Re: PD 70, Subarea E, 333 E. Benton Place

In response to your recent request, please be advised that the subject property is zoned Residential Business Planned Development No. 70 ("PD 70") and within Subarea E. According to your request, your client, Pup Social, is seeking to activate 3,498 SF of vacant commercial space within the existing mixed-use building located at 333 E. Benton Pl. Pup Social's proposed services will include dog grooming, dog boarding, dog walking and general retail use. Per your request letter, all of the proposed uses will take place indoors. You are seeking clarification if these uses are permitted.

Re: Minor Change to PD 70

Re: Site Plan Review request for Planned Development No. 70, Subarea E, Parcel O

#### LOWER LEVEL 02 PARKING STALL MODIFICATIONS:

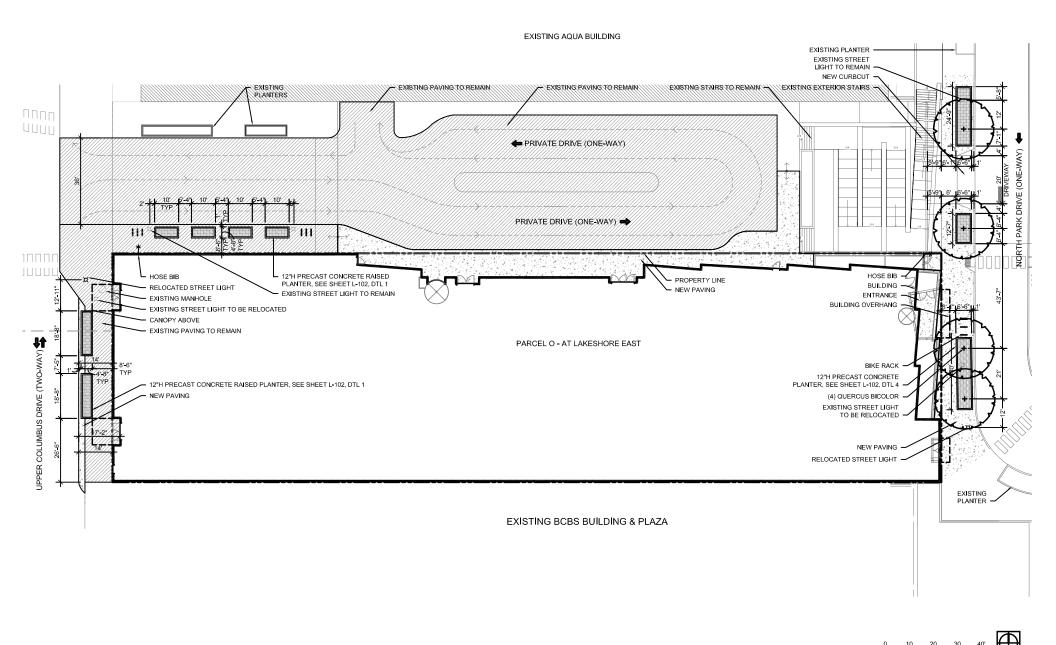
- (6) STALLS IMPACTED DURING EVENTS ONLY
- (1) STALL ELIMINATED FOR CONNECTION TO PARCEL O GARAGE

Re: Minor Change for PD 70, Loading vertical clearance at 211 N. Harbor Dr. and 455 and 460 E. Waterside Dr.

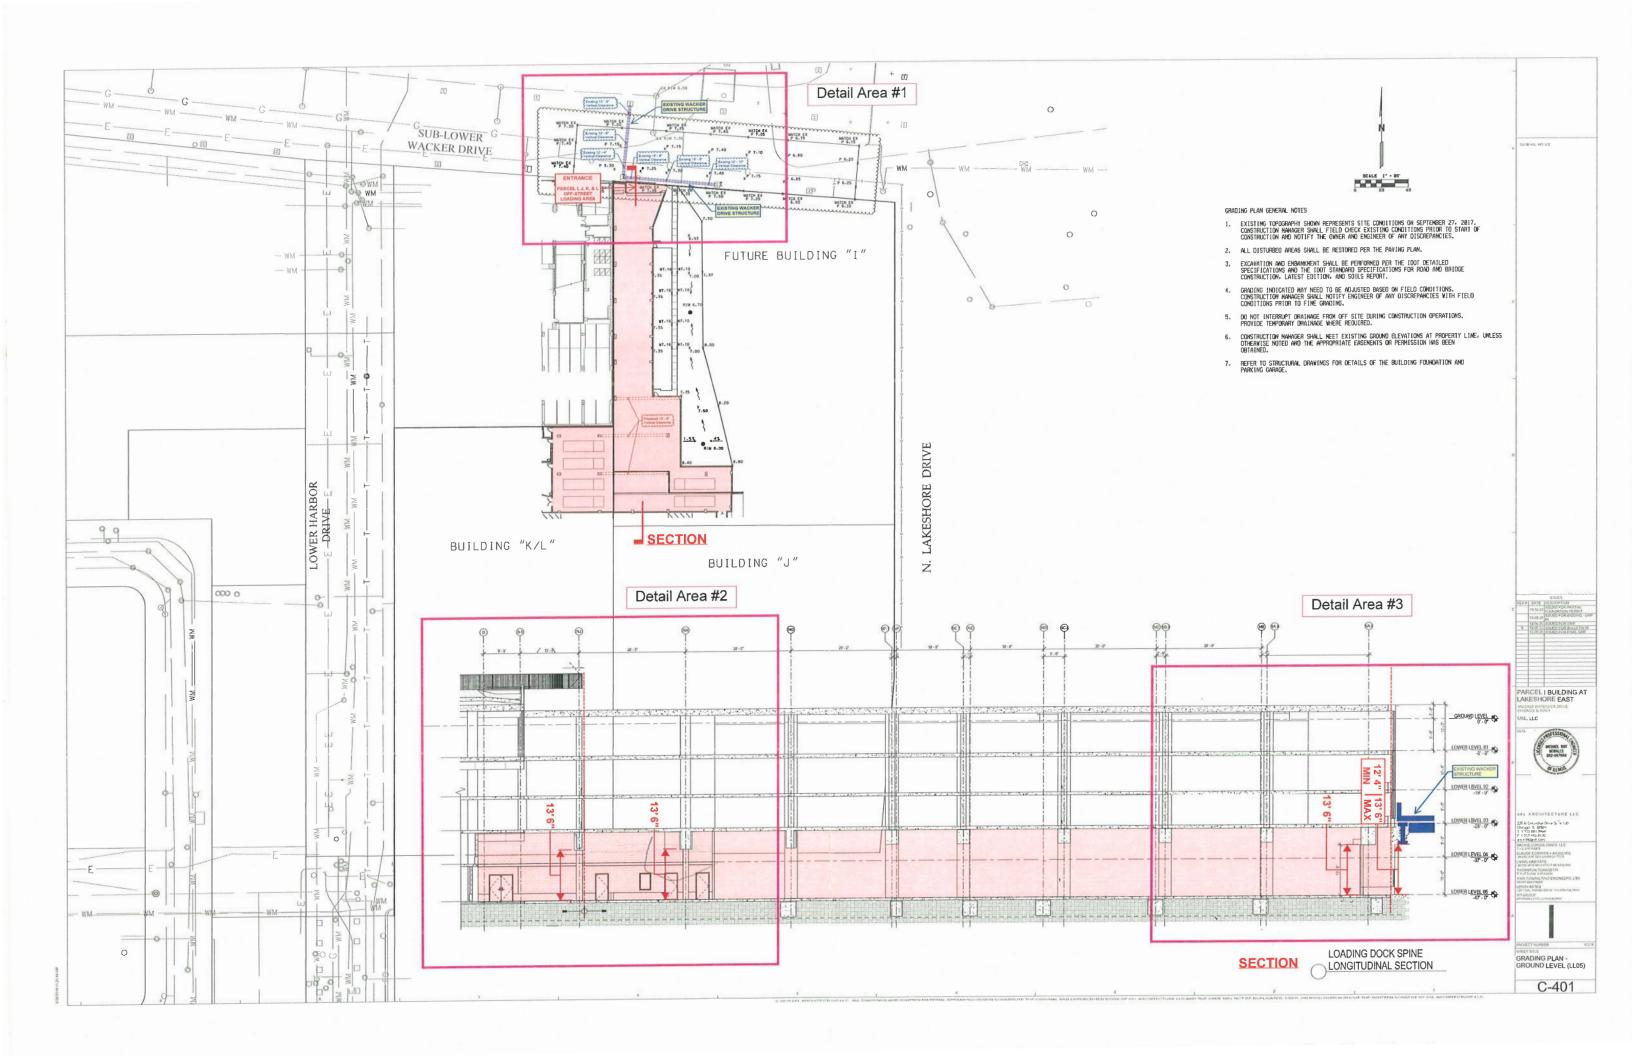
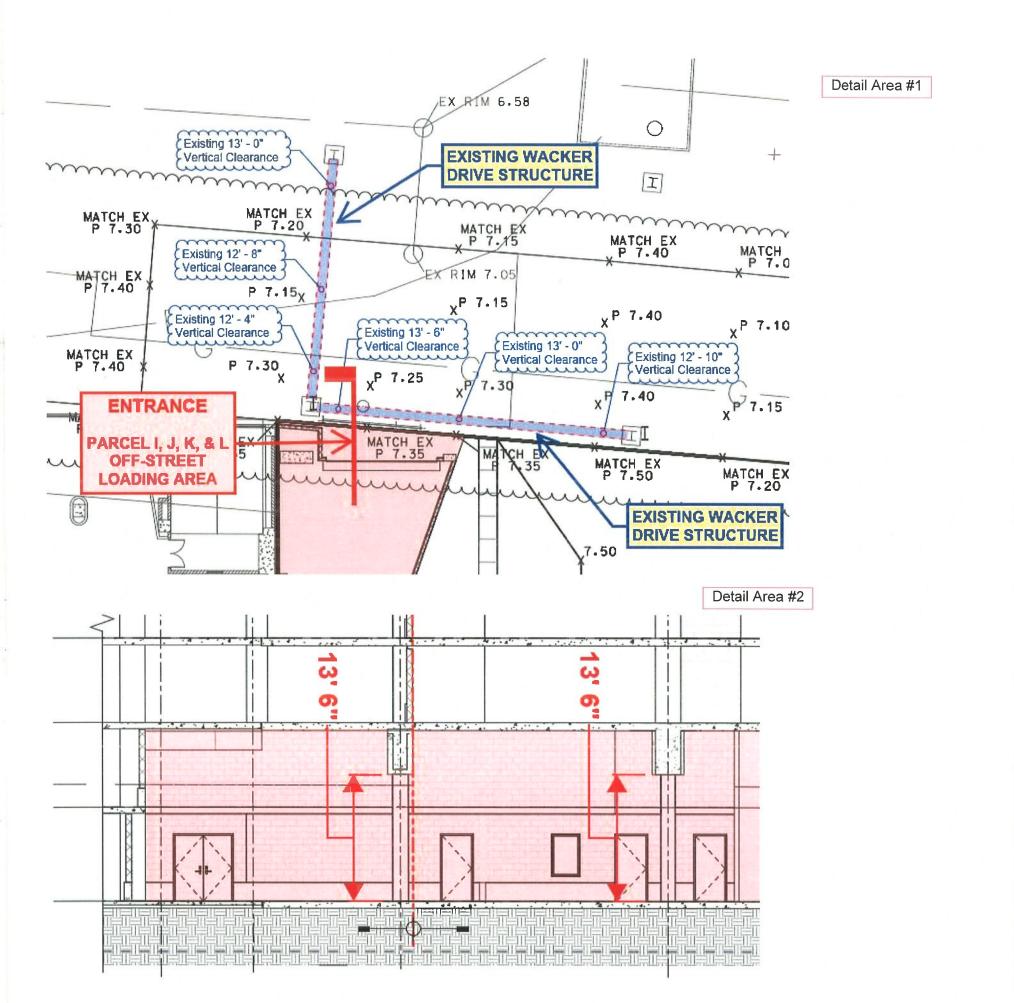
Lendlease has a controlling interest in the subject parcels and is seeking a minor change to reduce the 14 foot vertical clearance requirement for off-street loading areas to 13'-6" or less as shown on the attached drawings. The off street loading area for all three buildings proposed for Parcels I, J, K and L will be accessed from Sub Lower Level Wacker Dr. However, the approach to your property from Lower Level Wacker Dr. requires driving below the existing structure supporting the Intermediate Level of Wacker Dr. above. Numerous locations along this access route, including the girder parallel to your property line, limit the height clearance to 13'-6" or less.

With regard to your minor change request, the Department of Planning and Development has determined that allowing the vertical clearance reduction will not create an adverse impact on the Planned Development or surrounding neighborhood, will not result in an increase in the bulk or density, and will not change the character of the development, and therefore, would constitute a minor change. Also, the Department of Transportation is aware of this existing condition and has no objection to this request.

Accordingly, pursuant to the authority granted by the Chicago Zoning Ordinance and PD 70, I hereby approve the foregoing minor change, but no other changes to this Planned Development. This minor change is valid for twelve (12) months from the date of this letter unless action to implement the minor change is commenced within such time period and thereafter diligently pursued to completion, including, if applicable, construction consistent with the minor change as authorized by a building permit. If action to implement the minor change, including construction, does not begin within the time set forth, or does not proceed with reasonable diligence, then the approval will lapse and become null and void.

# PARTIAL BLDG 1 PLAN - PODIUM SETBACK AND BUILDING SETBACK DIAGRAM SCALE: N.T.S.

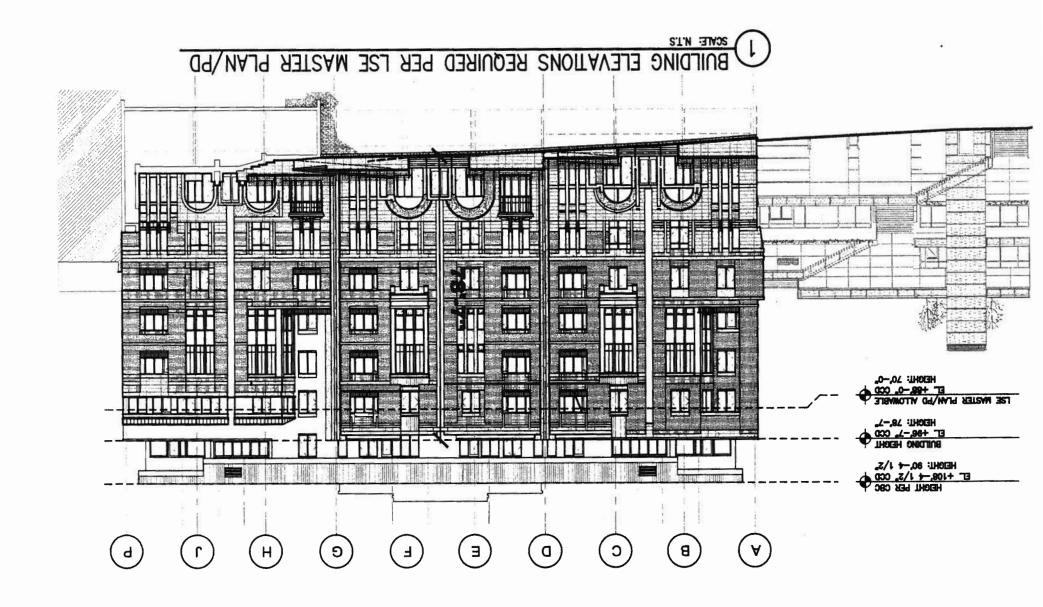
\* Sheet A2.10 indicates that the seventh-floor minimum setbacks from the perimeter wall on Building #2 are 6'6" on the west and 6'3" on the north. These are in substantial conformance with the required setbacks stipulated in statement #4 of the Minor Change letter dated December 22, 2005; and
